1	Ground floor plan
1105	Scale 1:100

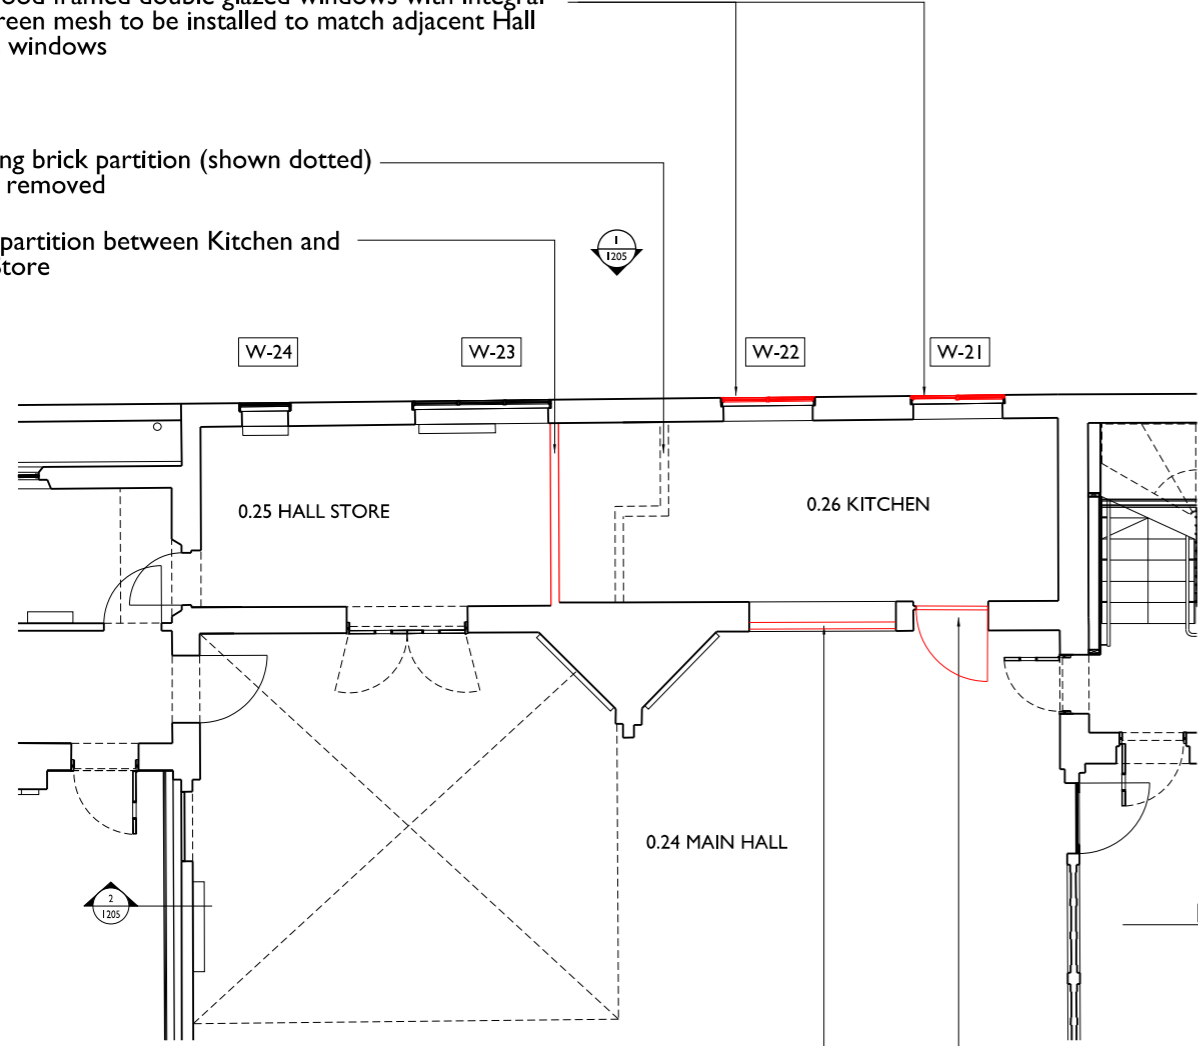
W21 and W22 - Existing louvred windows with metal grill surrounds to be removed. New painted external softwood framed double glazed windows with integral fly screen mesh to be installed to match adjacent Hall Store windows

Existing brick partition (shown dotted) to be removed

New partition between Kitchen and Hall Store

Fire-rated servery hatch to be replaced to match existing. Existing opening size to be retained.

Fire-rated kitchen door to be handed and replaced. Existing opening size to be retained.

2	Roof plan
1105	Scale 1:100

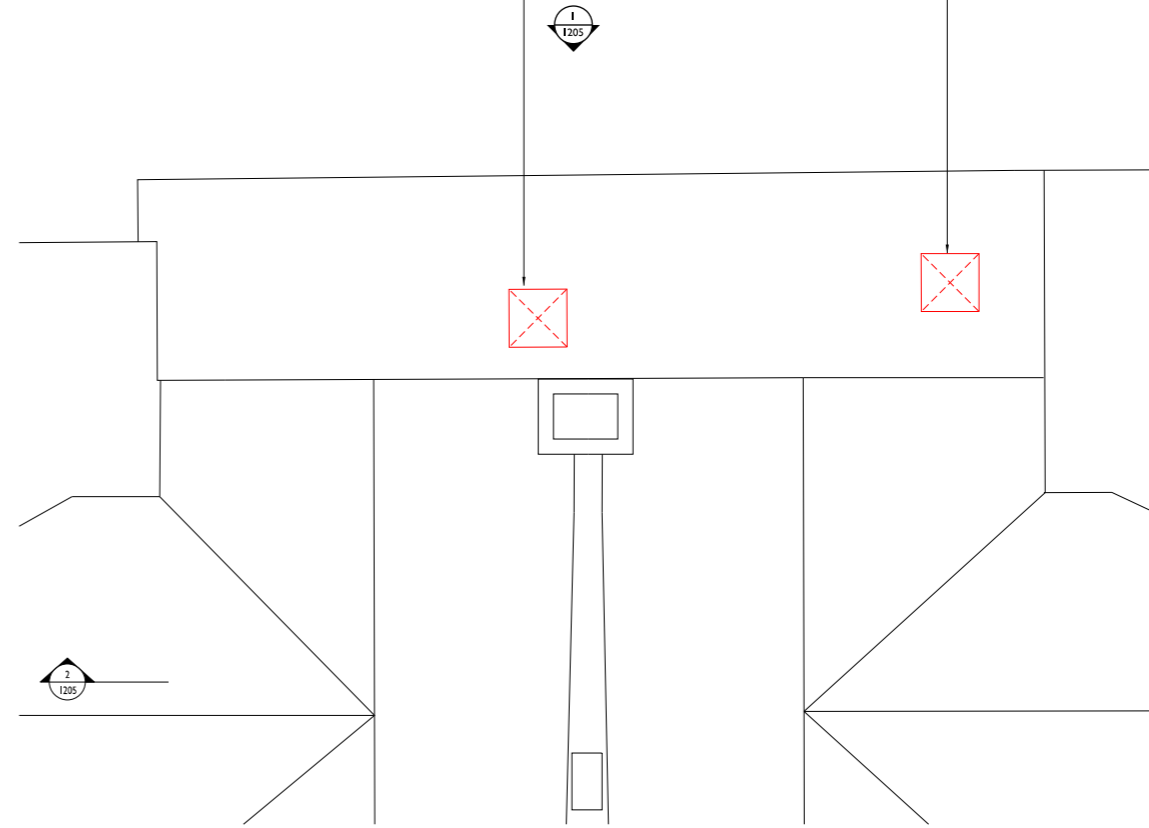
New 765w x 765d x 520h kitchen extract, to be painted black
